GENERAL SUMMARY

SUM-77 / 277 / 224
VARIOUS

CULVERT DETAIL
177 STA. 443+36

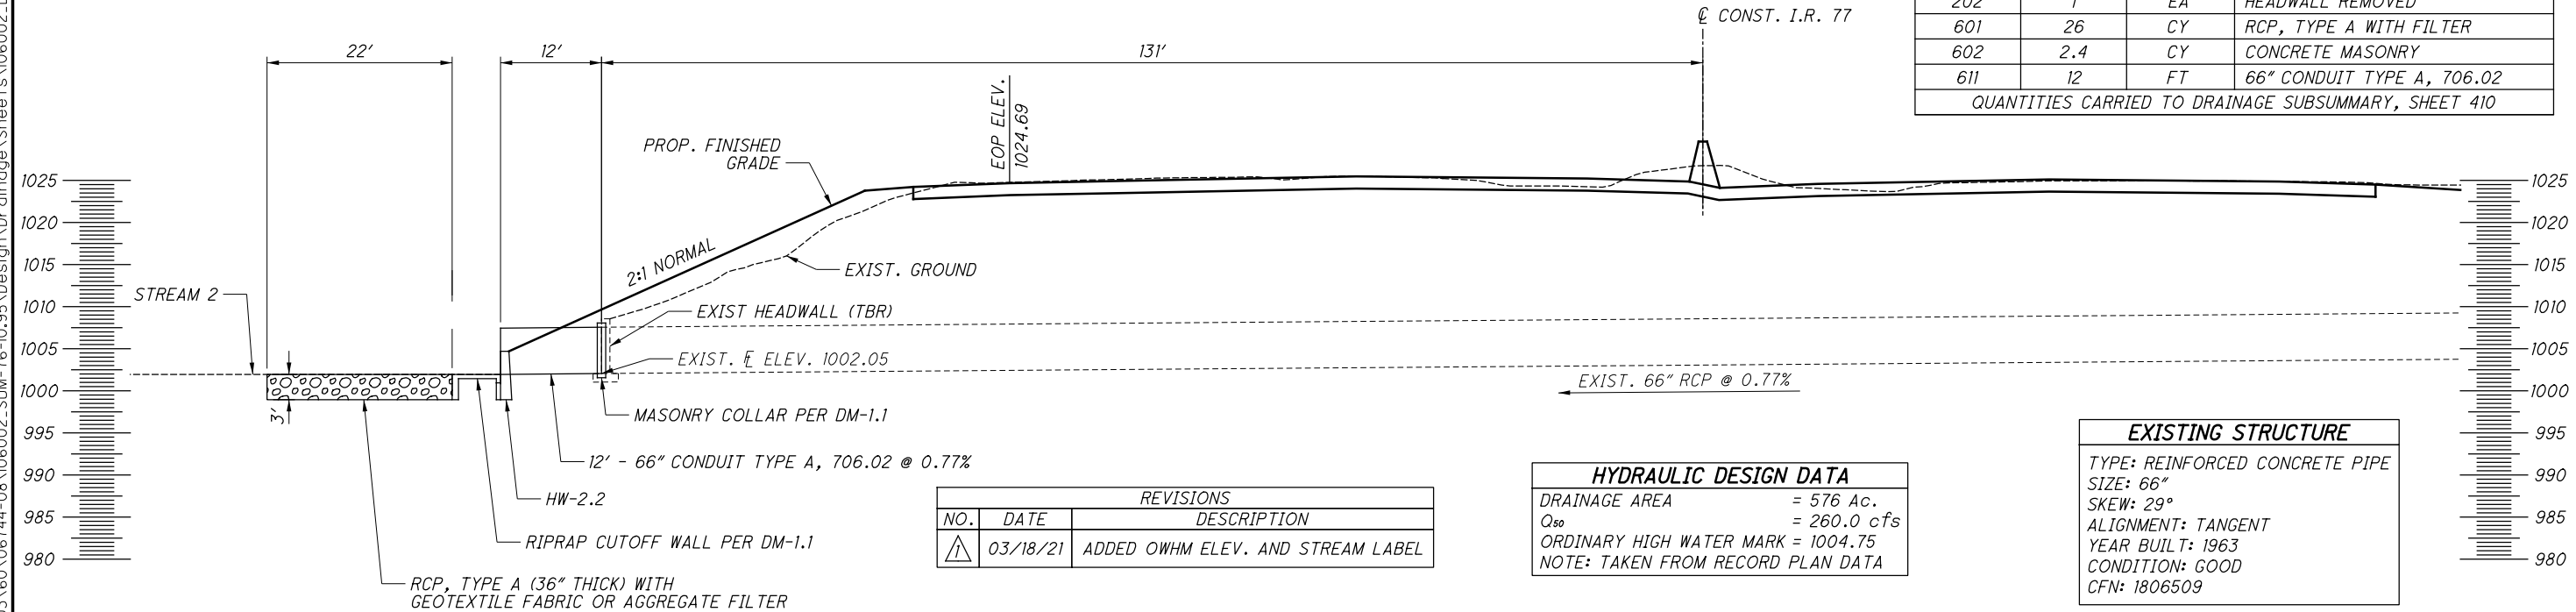
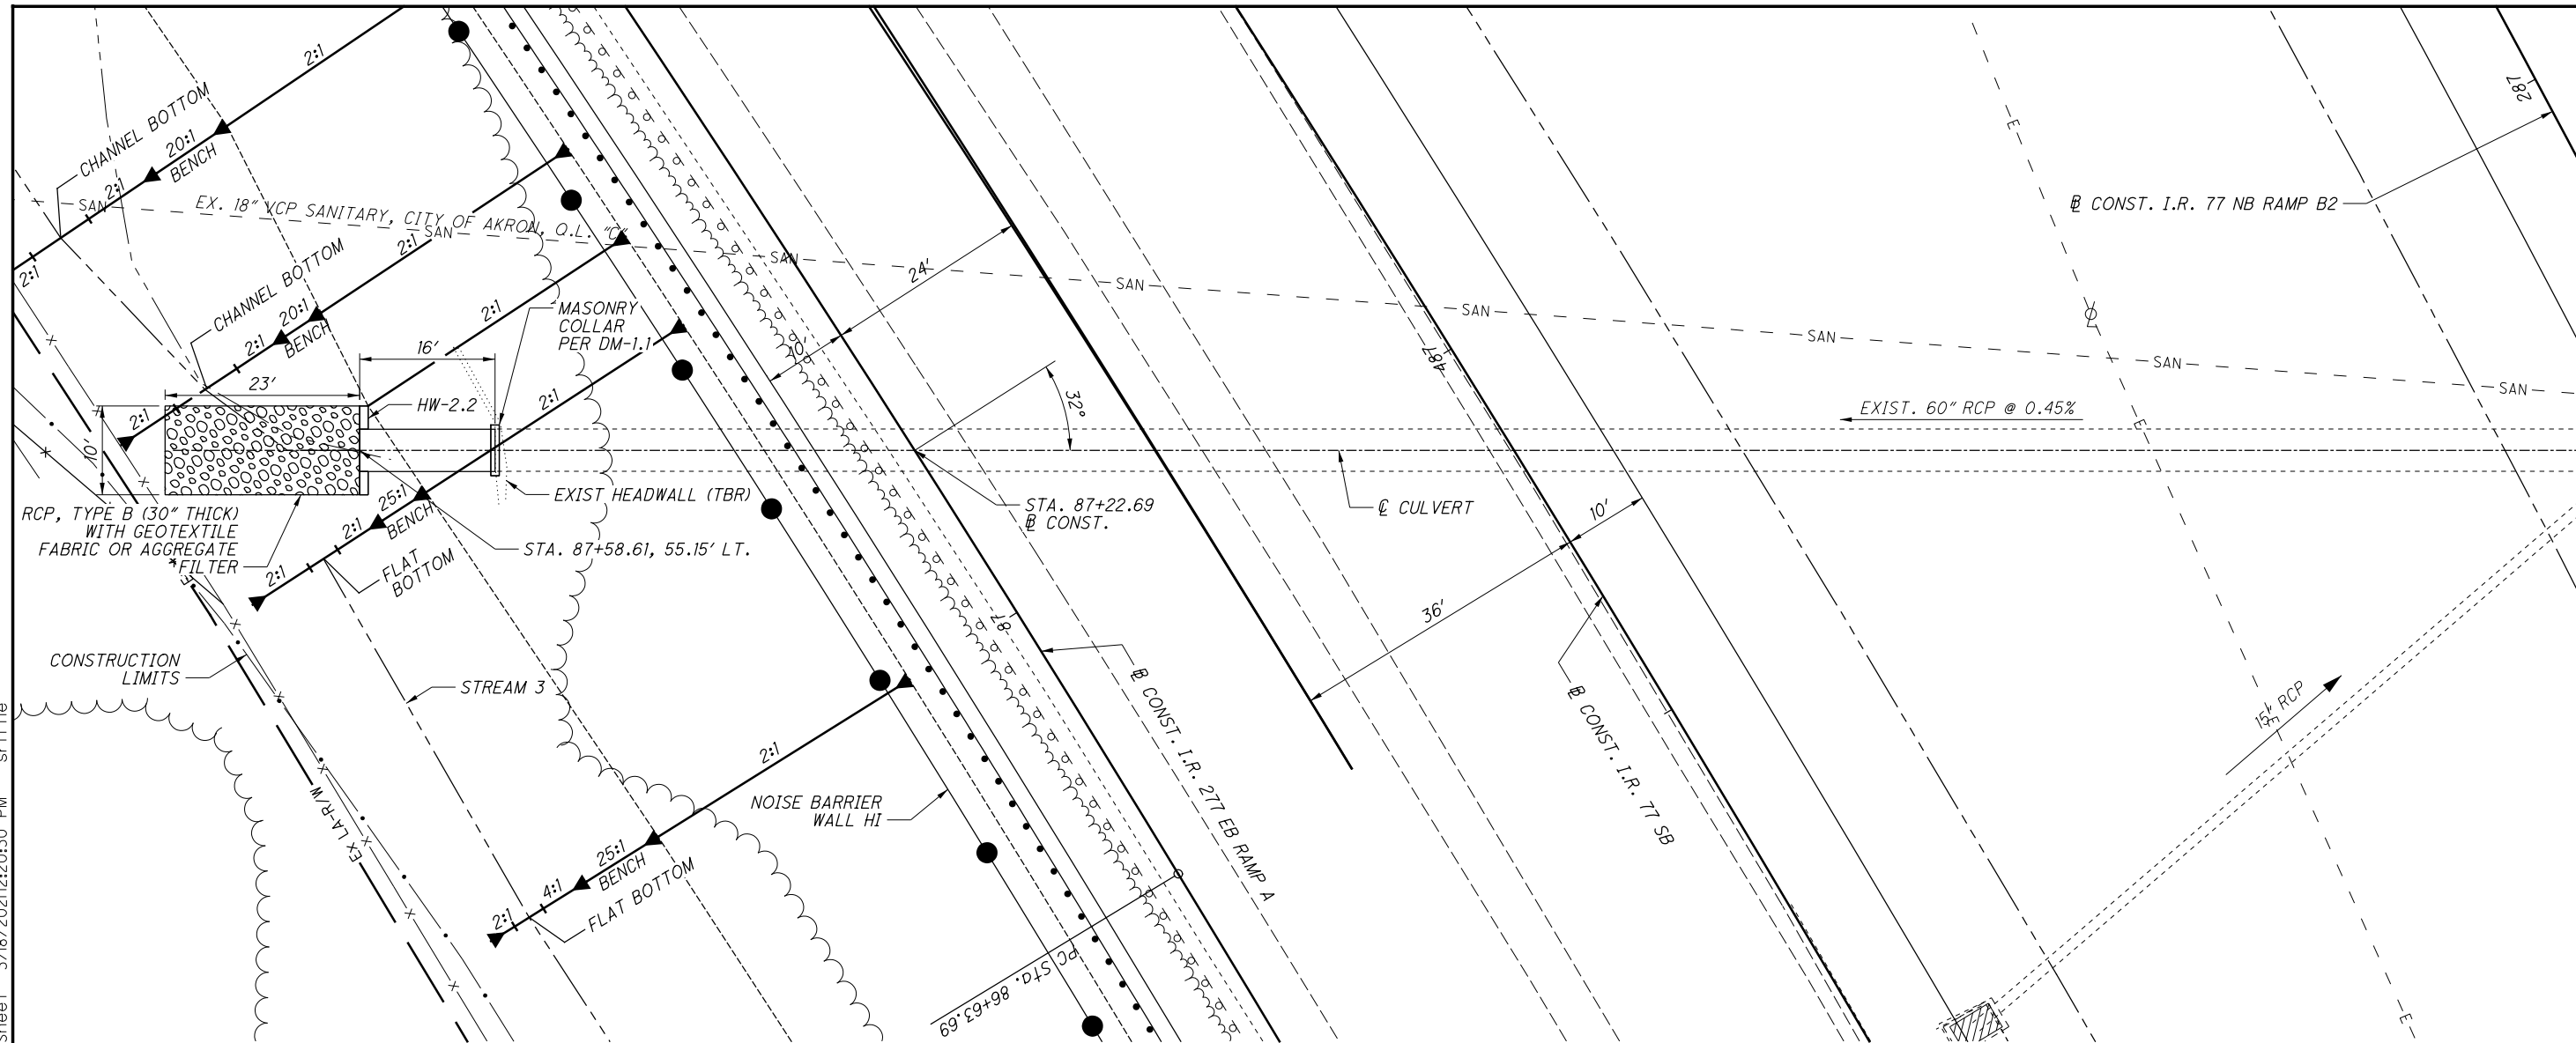
REVISIONS		
NO.	DATE	DESCRIPTION
1	03/18/21	ADDED OWHM ELEV. AND STREAM LABEL

HYDRAULIC DESIGN DATA	
DRAINAGE AREA	= 576 Ac.
Q ₅₀	= 260.0 cfs
ORDINARY HIGH WATER MARK	= 1004.75
NOTE: TAKEN FROM RECORD PLAN DATA

**CULVERT DETAIL
 RAMP A STA. 102+19**

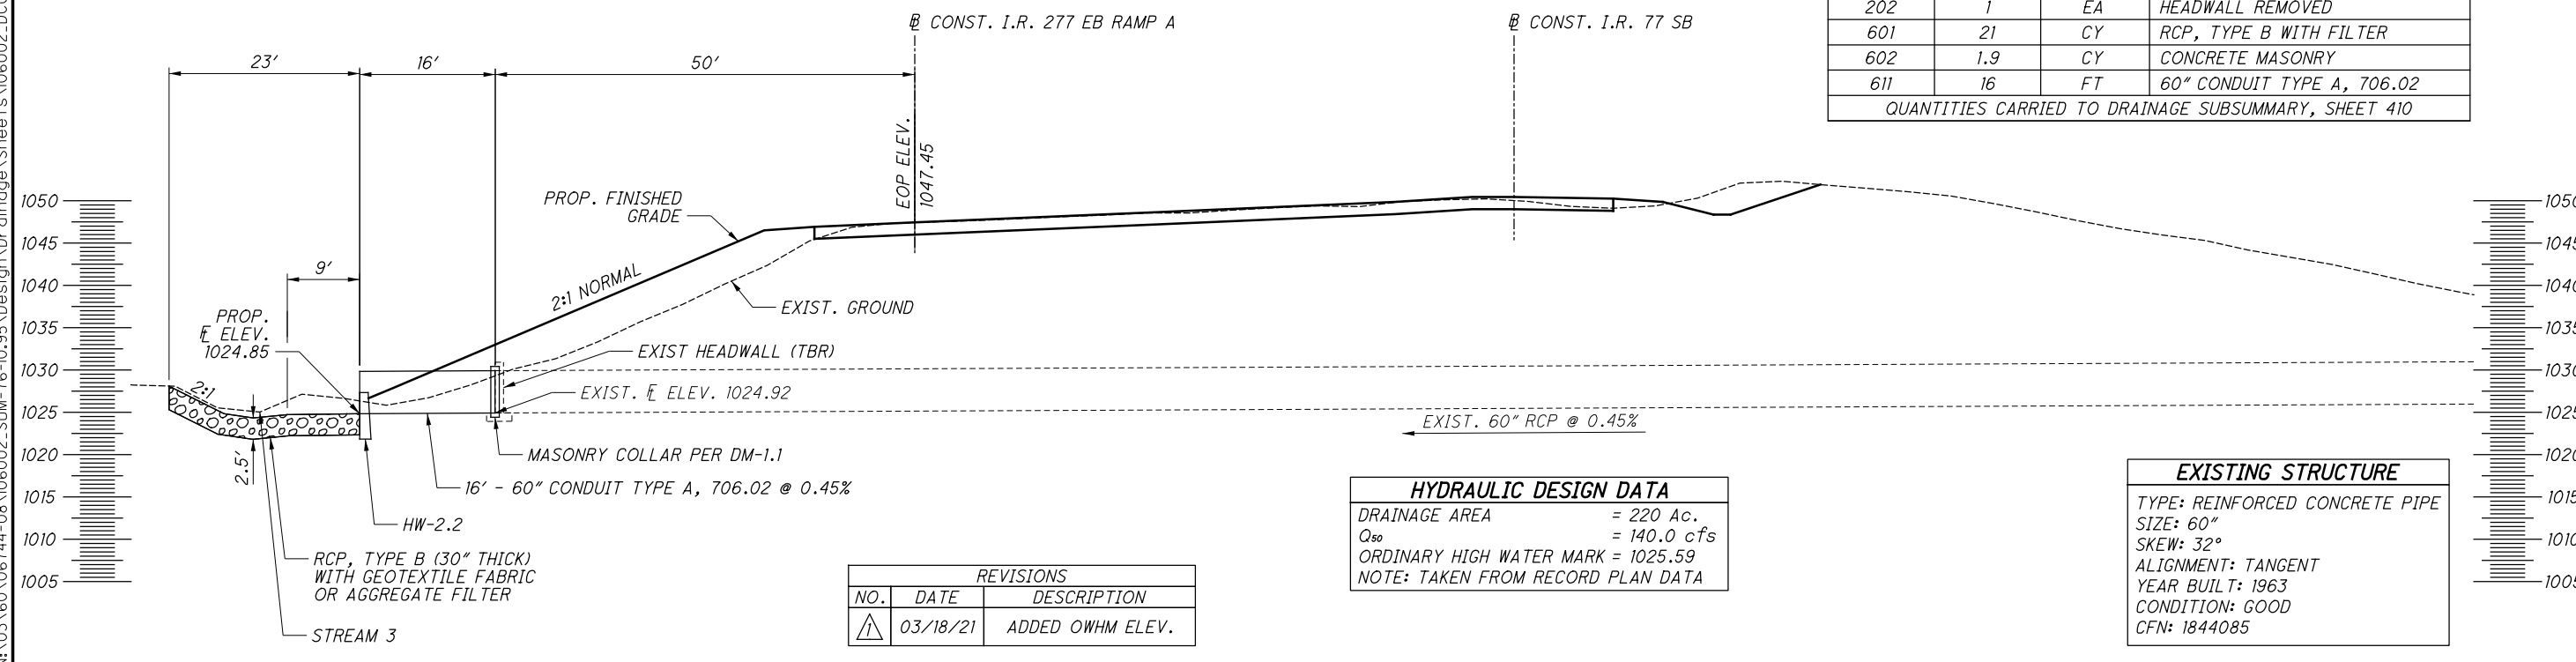
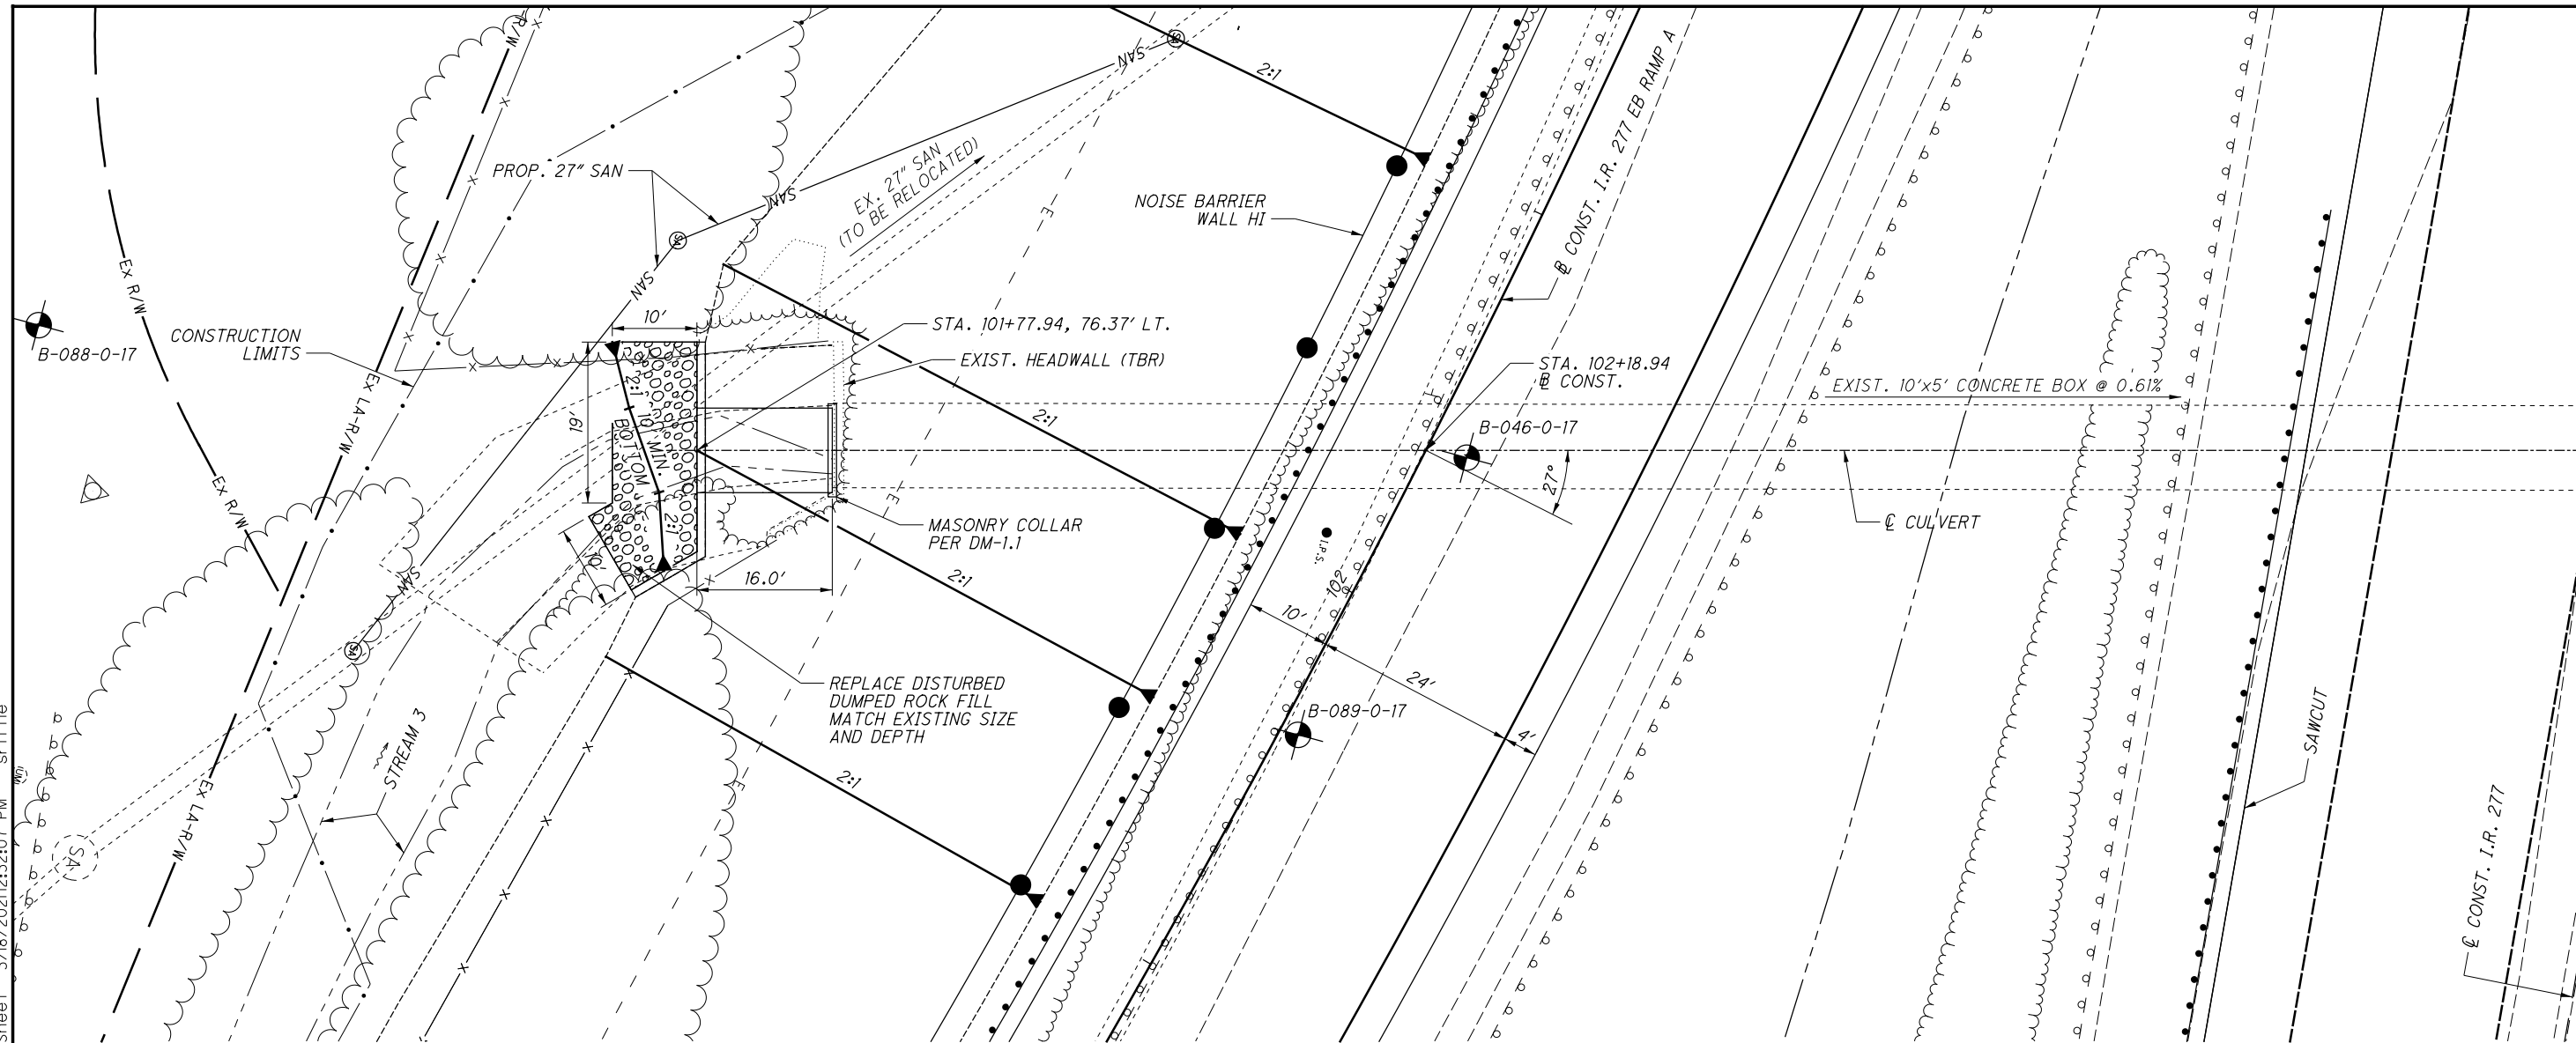
REVISIONS		
NO.	DATE	DESCRIPTION
1	03/18/21	ADDED OWHM ELEV.

HYDRAULIC DESIGN DATA	
DRAINAGE AREA	= 220 Ac.
Q_{50}	= 140.0 cfs
ORDINARY HIGH WATER MARK	= 1025.59
NOTE: TAKEN FROM RECORD PLAN DATA
